Docket Item # 5
BAR CASE #2006-0161

BAR Meeting
July 26, 2006

ISSUE: New residential building
APPLICANT: Anna Maria & Michael Dechert
LOCATION: 804 Pendleton Street
ZONE: RB Residential

**Figure 2 -
Proposed plan**

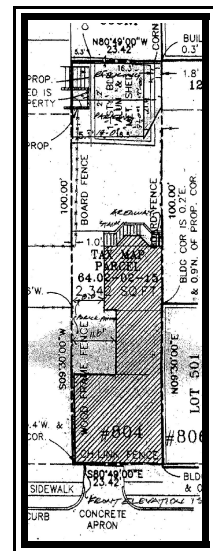
The proposed house will be composed of three sections. The front block is square in plan. It will abut the house at 806 Pendleton Street on the west side and extend across nearly the entire width of the lot and leaving 11" between the wall and the property line on the east side. The narrower middle section will be rectangular in plan. It will also abut the house at 806 Pendleton Street on the west side and will be set back 11' from the east property line. The rear section is wider than the middle section and square in plan. It will be set back 8' from the east property line and will extend beyond the house at 806 Pendleton Street on the west side. The house will be 56' long. It will be 28'10" high at the front block and will step down in height twice with the middle section being 27'1" and the rear section 25'10". The house will be two stories with a raised basement and a mansard roof. It will be constructed of CMU. The main block of the house will be clad in brick on the north (front), east (side) and south (rear) facades. (A

brick sample will be made available to the Board at the hearing.) All other facades will be stucco. The roof will be clad in standing seam metal to be painted. There will be wood trim, wood windows, wood doors and round metal down spouts and half round metal gutters. The windows will be simulated divided light windows by Pella, Kolbe and Kolbe or equivalent. The window sills and lintels in the brick clad block will be brick soldier courses. The sills and lintels in the stuccoed portions will be projecting masonry with stucco finish.

Figure 4 - Proposed side (west) elevation

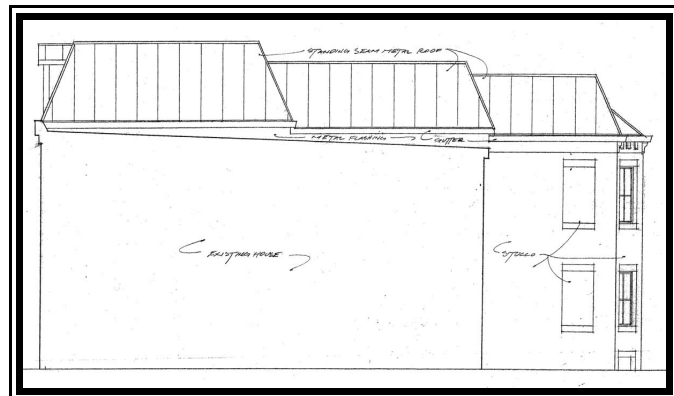
The 56' long west elevation will be partially obscured by the adjacent houses at 806 and 808 Pendleton Street. The attic level and the rear 15' of the proposed house will extend beyond the neighboring houses at 806 and 808 Pendleton Street and will be visible in oblique views from Pendleton Street and the alley. It may also be partially visible from Alfred Street. The narrow sliver of wall visible above 806 Pendleton Street will be clad in metal flashing to

ensure that the joint between the new and existing house is watertight. The back section of the proposed house that extends beyond 806 and 808 Pendleton Street will be covered in stucco. There will be two rectangular areas inset approximately 1" to suggest blind windows at the south end of this section on the first and second stories. The inset areas will have sills and headers and will be stuccoed. The most prominent feature of the west elevation will be the three mansard roof sections clad in metal roofing. The side of the attic story dormer at the front will be visible, with metal clad walls and a standing seam metal roof.

Figure 6 - Proposed rear (south) elevation

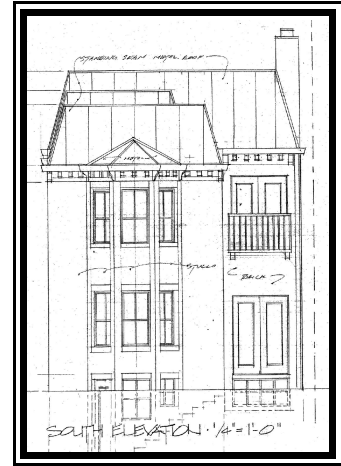
The south (rear) elevation will be visible from the alleys to the south and west and may be visible in through block views. The south elevation of the front block will have a pair of fully glazed doors in the first and second stories. There will be a simple metal railing across the doors on the second story. The south elevation of the rear block will be 15'5" wide. There will be a two story, angled bay centered in the rear elevation. There will be a two-over-two window in each face of the bay on the first and second stories. There will also be window in the center and east faces of the bay in the basement level. These two-over-two windows will only be partially above grade. There will be a door in the west face of the bay in the basement level. Steps and an areaway will wrap the bay on the south facade and will provide access to the basement level. The HVAC units will be located in the areaway and thus will be screened from view. The bay will have a wood cornice and metal roof. The metal clad mansard roof of the rear block will terminate in a wood cornice with brackets. The rear block will be 25'10" high.
